DESCRIPTION OF PROPOSED CHANGE NPF-10/15-52 AND  
SAFETY EVALUATION

This is a request to revise Technical Specifications 3/4.2.4 and 3.3.1 (Table 3.3-1, Action 6) and associated bases.

Figure 3.2-1 DNBR margin operating limit based on COLSS.

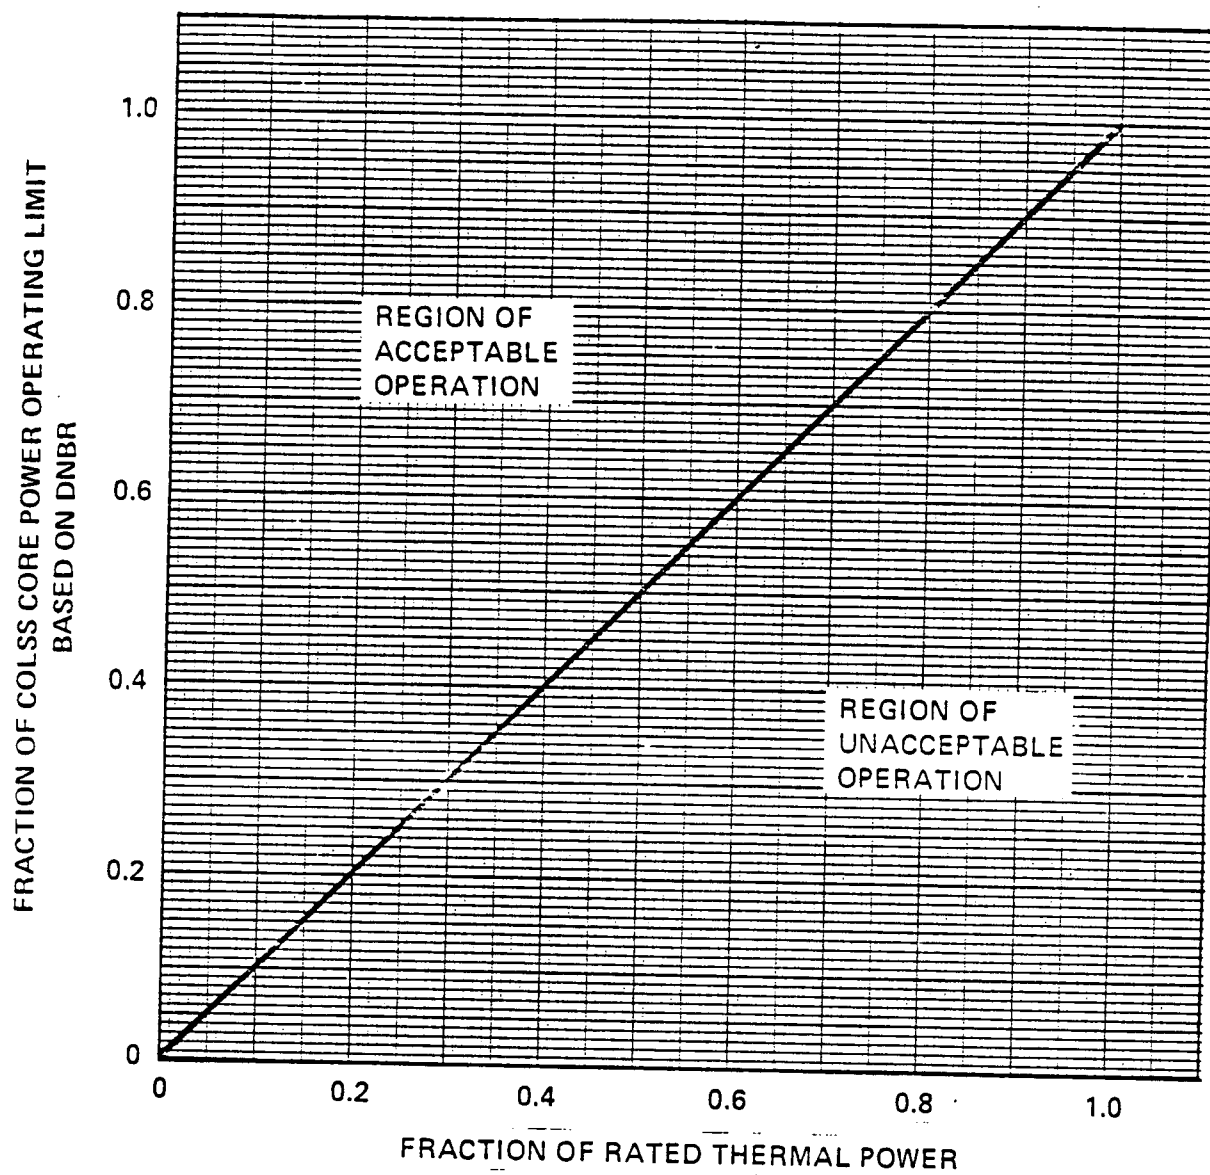
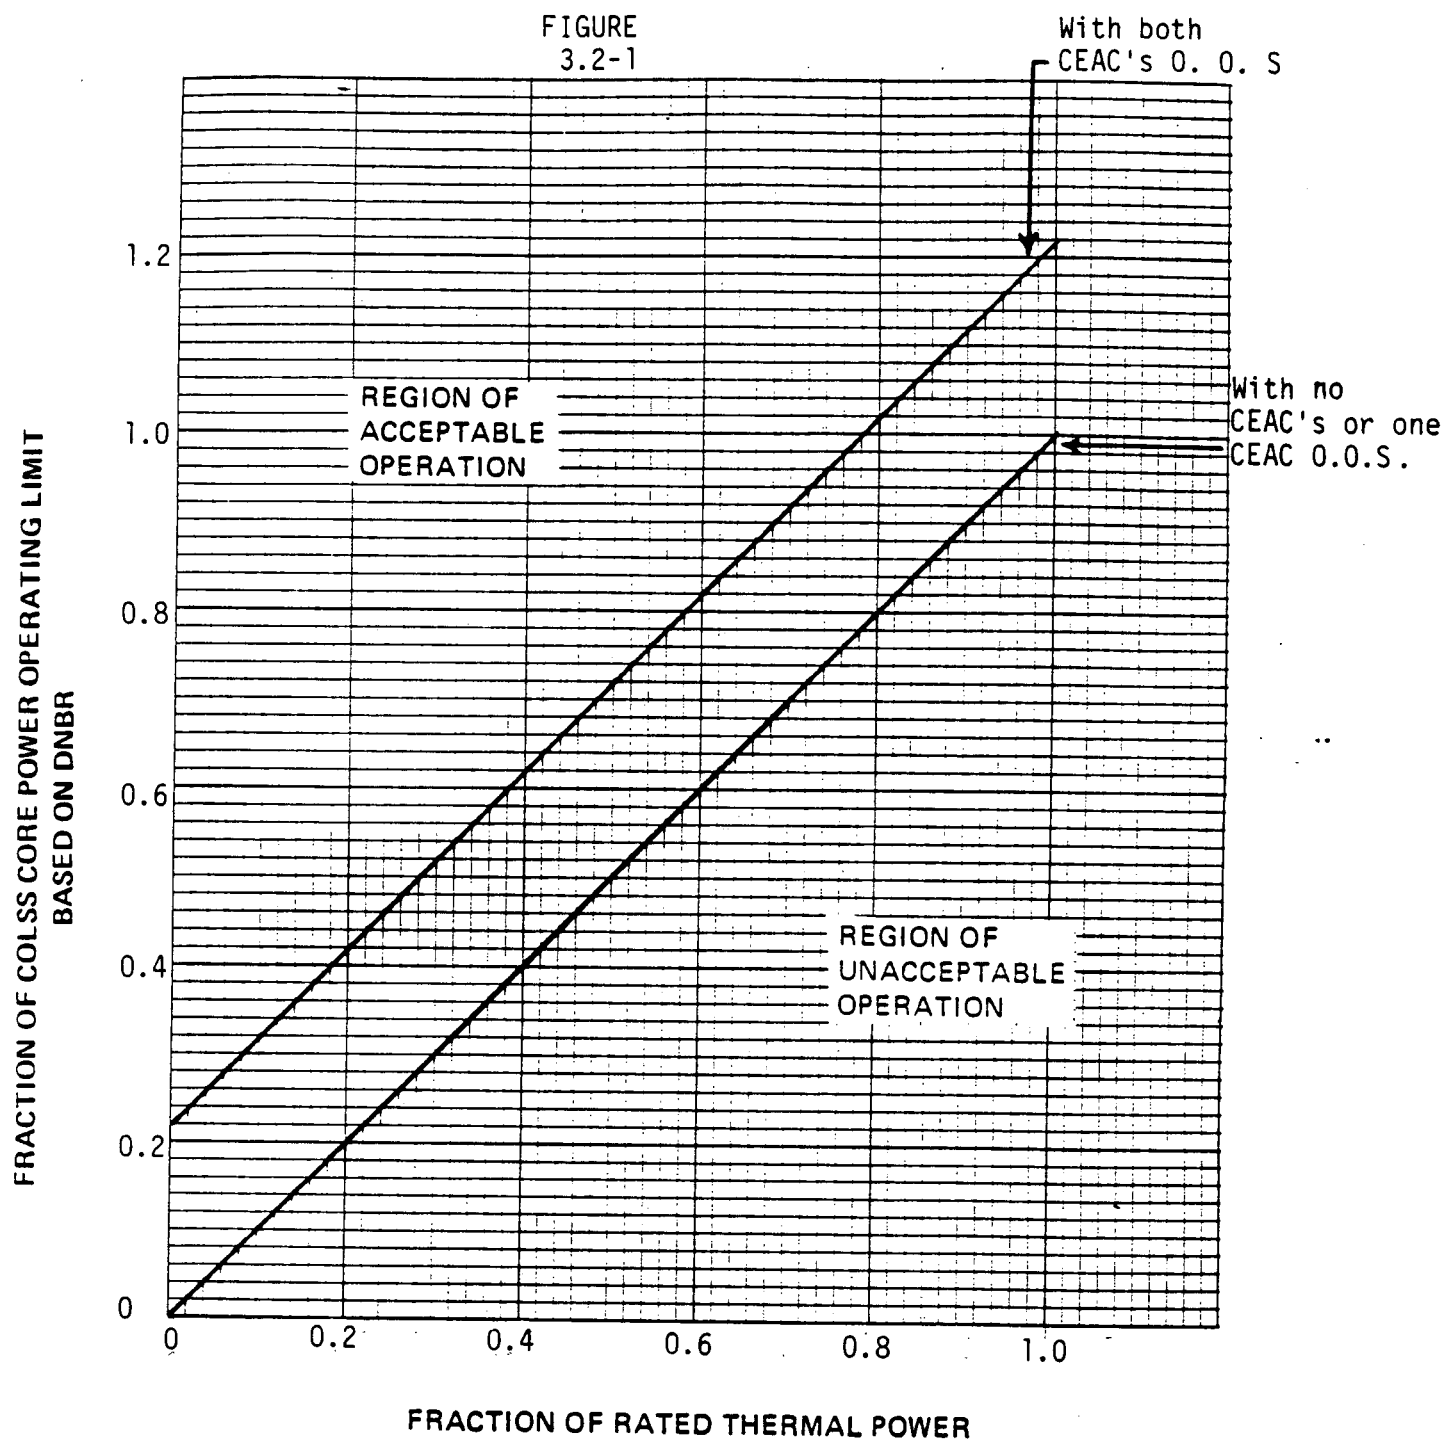
The COLSS assures that enough thermal margin is available so that the four pump loss of flow does not violate the DNBR fuel design limit. Since more margin is required to protect against CEA drops when both CEAC's are out-of-service, an additional penalty on the COLSS calculated power operating limit is needed. This is the reason for the 22% penalty incorporated into Figure 3.2-1 for both CEAC's out-of-service.

Figure 3.2-2 DNBR margin operating limit based on core protection calculators.  
(COLSS out of service)

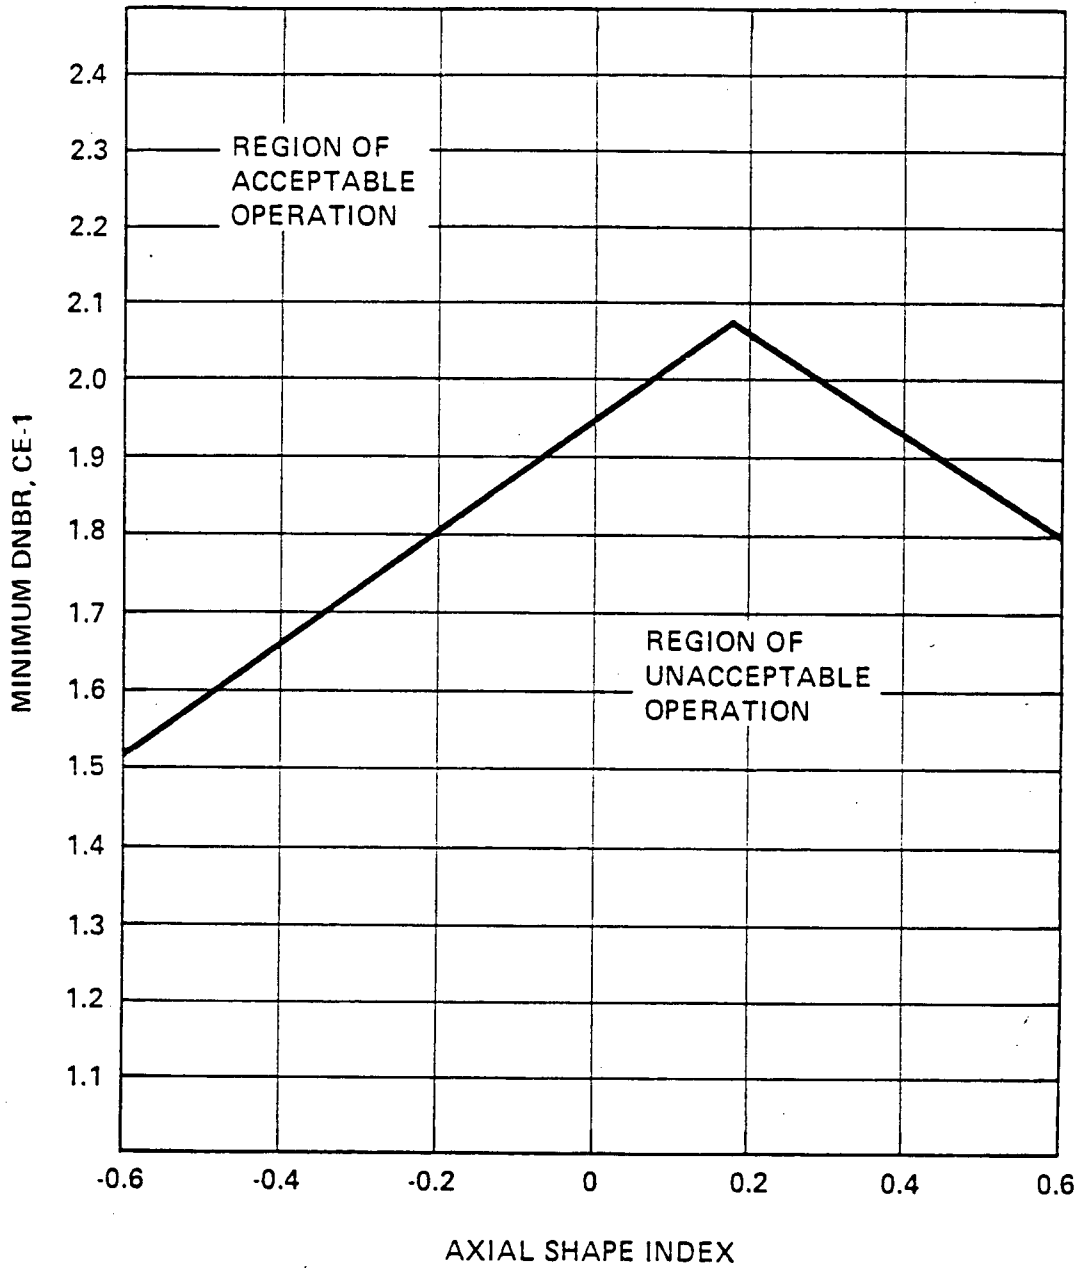
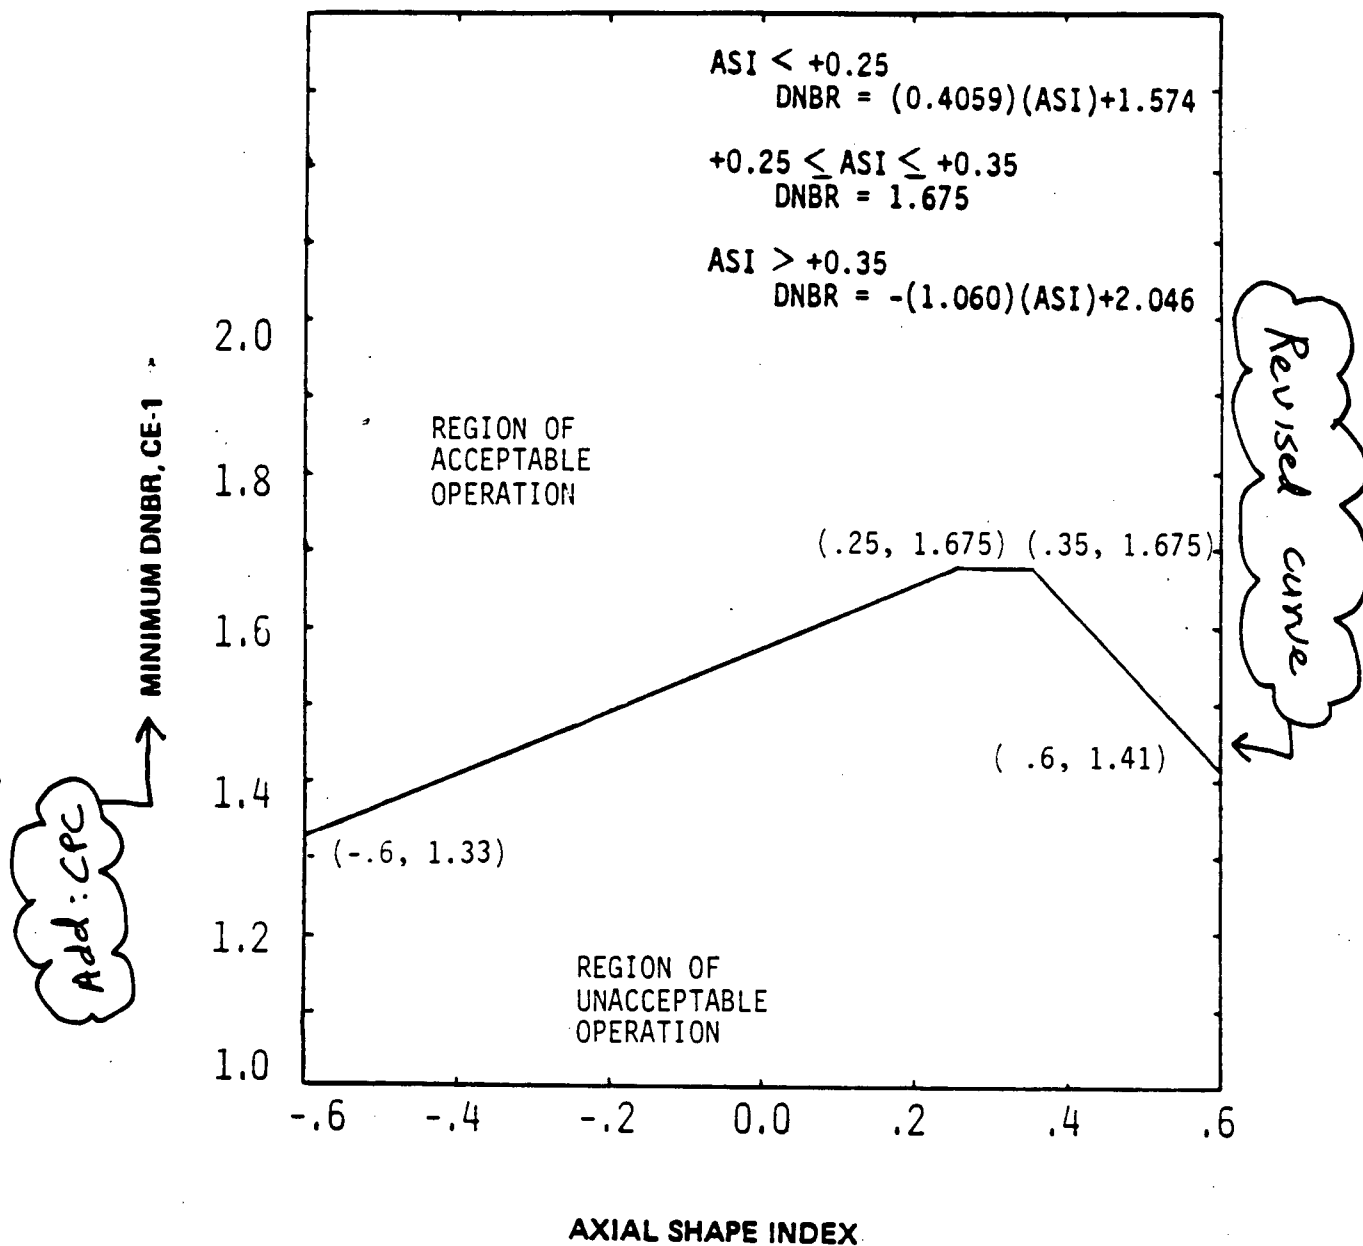
This proposed change increases the COLSS out-of-service margin by 10%. The thermal margin gain is reflected in the new COLSS out-of-service limit lines as presented in revised Figure 3.2-2 and new Figure 3.2-3 of Attachment B. These lines take into account a reevaluated CPC overall uncertainty consistent with the requirements of LCO monitoring.

Note that two COLSS out-of-service curves are being proposed: one applicable at and above 80% rated thermal power and one applicable below 80% rated thermal power. This is done to maximize allowable power level near full power operation.

Add: with RATED THERMAL  
POWER  $\geq 80\%$ .

change to: 3.2-3  
Figure 3.2-2

The dynamic uncertainty components included in the CPC DNBR calculation, but not required in the LCO monitoring system, are removed from the COOS DNBR limit line. Previously, with COOS, the CPC's provided the monitoring function on DNBR very conservatively using the larger safety system uncertainties.

The conservatisms in the CPC uncertainty analysis must cover many transient conditions and a very wide operating space. By limiting these requirements to be consistent with LCO monitoring, the uncertainty factors which are required can be reduced. The margin corresponding to this reduction in uncertainty factors is used in providing a new, less restrictive COLSS out-of-service limit. Note that none of the CPC channels is affected and, therefore, the safety system setpoints are unchanged. The margin credit for the reduced uncertainties is used to determine a less restrictive COLSS out-of-service limit.

Figure 3.2-2 DNBR margin operating limit based on core protection calculators.  
(COLSS out of service)

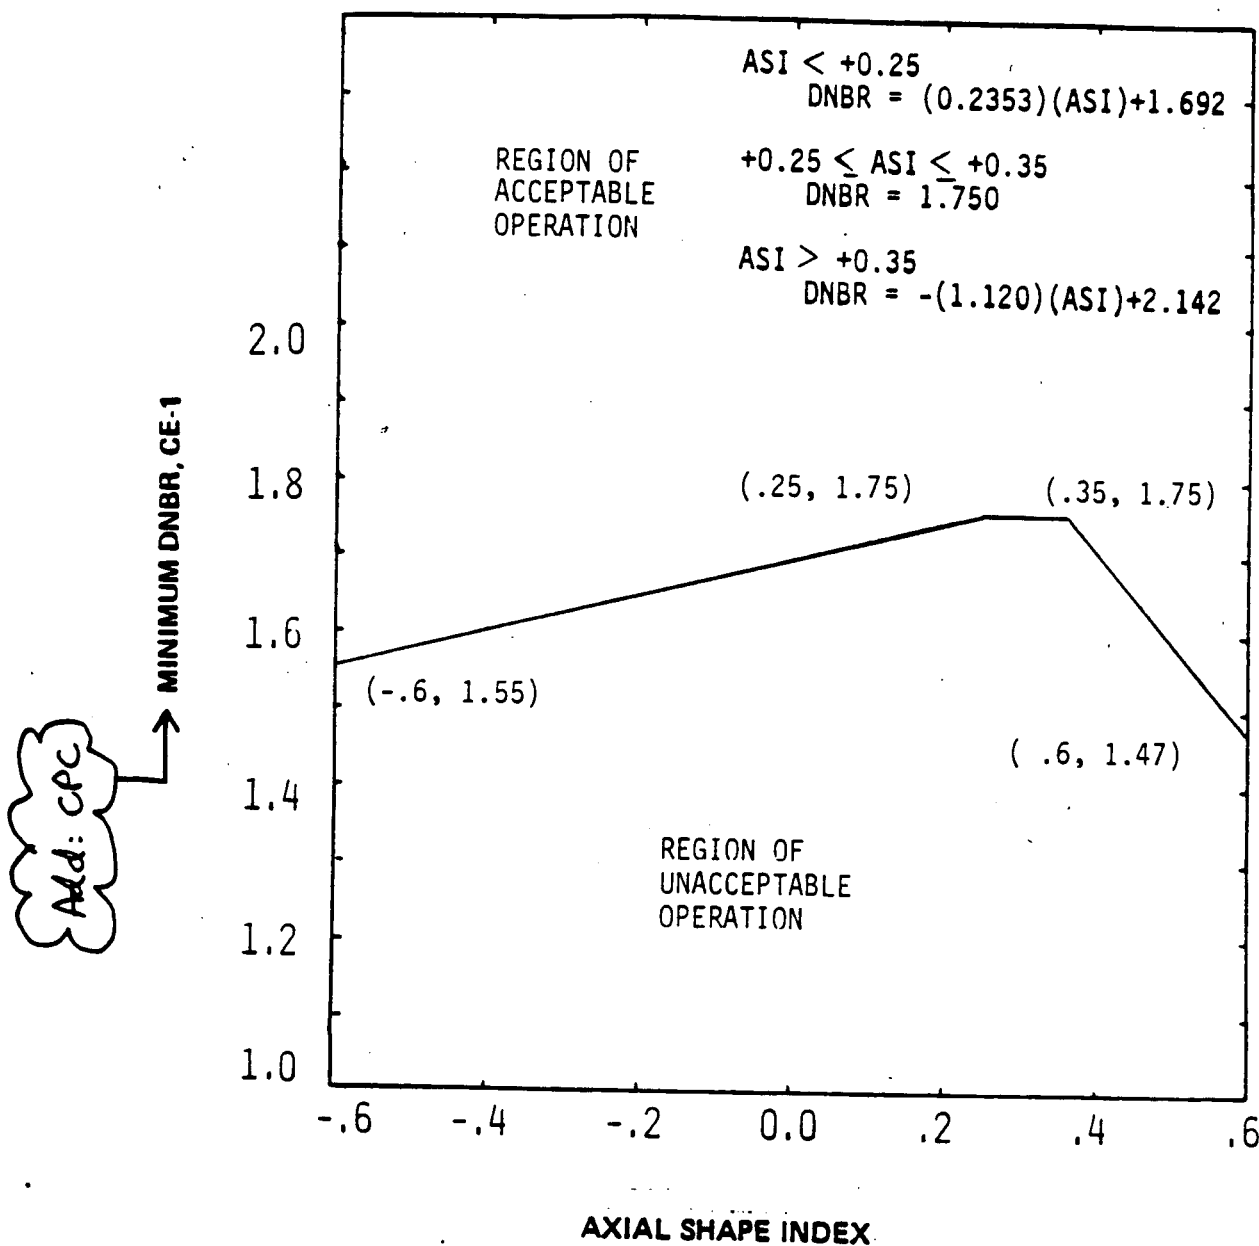
Change to: 3.2-3

Add: with RATED THERMAL  
POWER < 80%.
